AIRWORTHINESS DIRECTIVE

SUBJECT: Inspection, replacement and maintenance of l'Hotellier couplings.

SIGNED: 	For and on behalf of:		
CHIEF TECHNICAL OFFICER AIRWORTHINESS	THE GLIDING FEDERATION OF AUSTRALIA		
GFA AD 177	ISSUE: 7	9 May 2001	Page 1 of 9

FIGURE 3. ACCEPTABLE LOCKING PINS

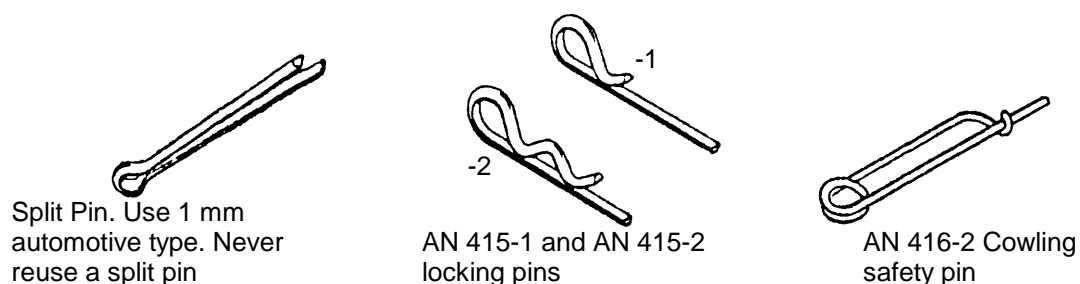
Before next flight all l'Hotellier couplings having a check hole must be safety locked. The locking must be checked at each Daily Inspection.

Acceptable methods of safety locking includes installing the pin types shown in Figure 3 and using of safety wire. Other methods of locking the couplings include Wedekind Safety Sleeves, Uerling type sleeves and the LS Sleeve as used on the LS 4. Because these other types of locking mechanism are significantly bulkier than the safety pins or wires shown in Figure 3 each type must be specifically approved for use in a particular aircraft type. If an aircraft type is approved for the use of other locking methods then it will be shown in the Flight and or Maintenance Manual or in the specific GFA AN for the type.

FIGURE 4. DRILLING THE LOCKING HOLE

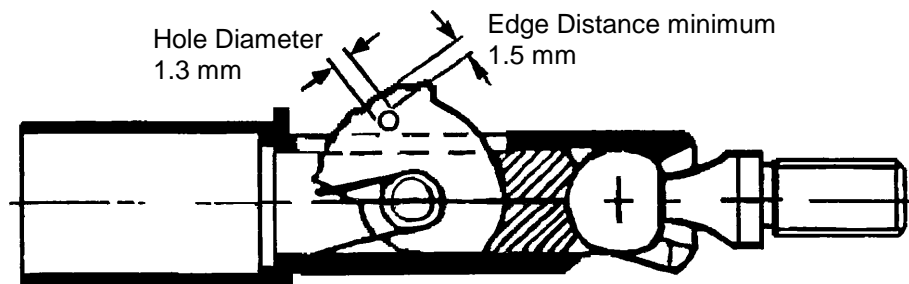
Before 31 July, 1998 all cam style l'Hotellier couplings which do not have a hole for the safety pin must be modified by drilling a hole as shown in Figure 4 using the following procedures:

- a) Remove the connector from the aircraft.
- b) Fit a coupling ball so that the coupling is in the connected state.
- c) Drill a 1.3 mm \varnothing hole as show in Figure 4. Clean the coupling and ensure no swarf remains.
- d) Reinstall the couplings. Ensure that the lock nuts are secured.
- e) Check the control surface deflections and freeplays of all control circuits which have been disturbed.

Once the holes have been drilled safety pins as per Figure 3 or lock wire must be fitted. When fitting the pins for the first time clearance around the fitting must be checked as some designs do not permit the installation of the safety pins due to fouling with the adjacent structure and in these instances locking wire must be used.

FIGURE 5. BALL WEAR MEASUREMENTS

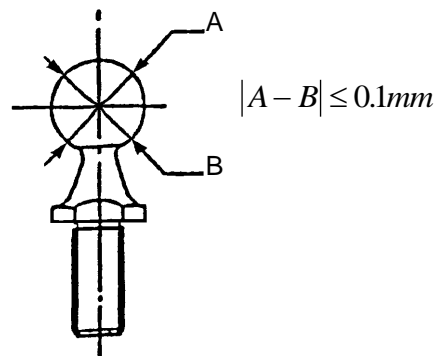
All balls must be checked for wear, as per Figure 5, at 500 hour intervals and during Annual Inspections, whichever comes first. The maximum out of round $A - B$ or $B - A$ is 0.1 mm

It is recommended that the fit of the ball in the fitting be checked by unbolting the ball from the control system and installing it in the coupling and attempting to rotate it. Any variation in the torque needed to rotate the ball is an indication of wear and ball replacement should be considered.

FIGURE 6. LOCKING PLATE EXTENSION

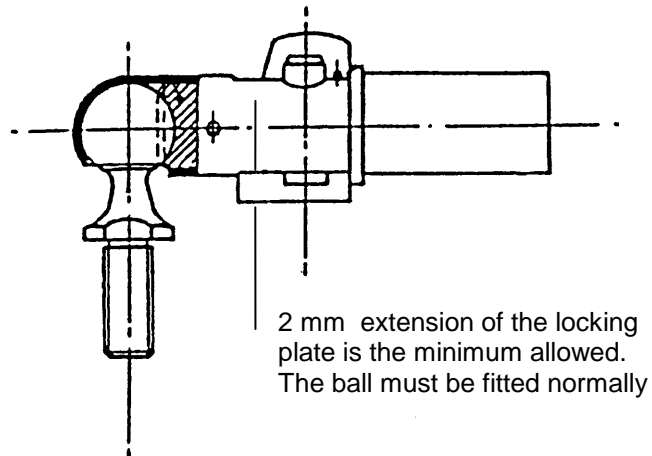
At each annual inspection the projection of the locking plate must be checked as per Figure 6. This measurement is an indication of the combined wear of the ball and coupling. If replacing the ball does not bring the extension back into tolerance then the coupling is excessively worn and must be replaced.

FIGURE 9. REPLACEMENT 961S-150-150.L3 BALL

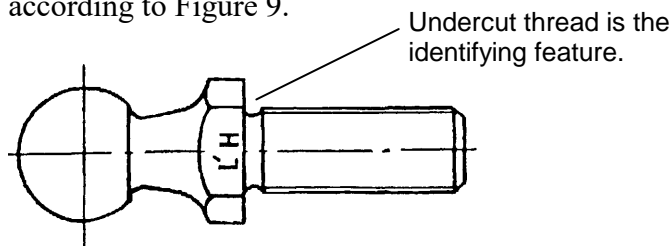
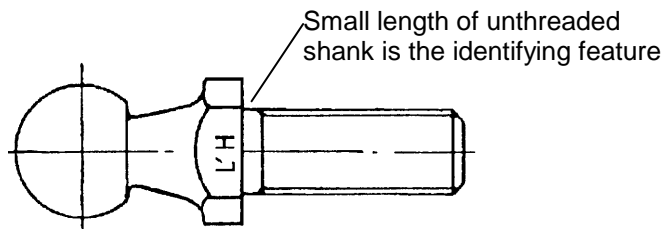
Since the last issue of this AD l'Hotellier have redesigned some of the balls to remove the undercut thread and introduce a small length of shank. The original design is shown in Figure 8. Balls with redesigned threads are identified as 961S-150-150.L3 according to Figure 9.

FIGURE 10 MODIFIED MOUNTING FOR 961S-150-150.L3 BALL

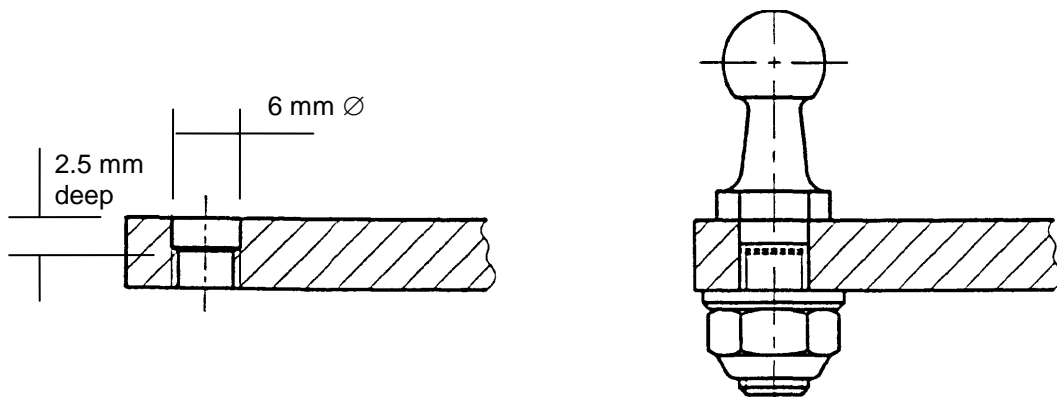
Because of the redesigned thread the mounting brackets must be modified to accept the new thread. Where the ball is mounted at

90° as shown in Figure 10 and there is a nut on the ball then the plate may be drilled out to accept the 961S ball.

The ball may be installed in end fittings by installing 2.5 mm of washers under the ball flange. Because this changes the geometry of the control system the control deflections or dive brake locking forces must be checked and adjusted to bring them back into tolerance.

The installation of 961S-150-150.L3 balls in any other designs requires formal design approval.
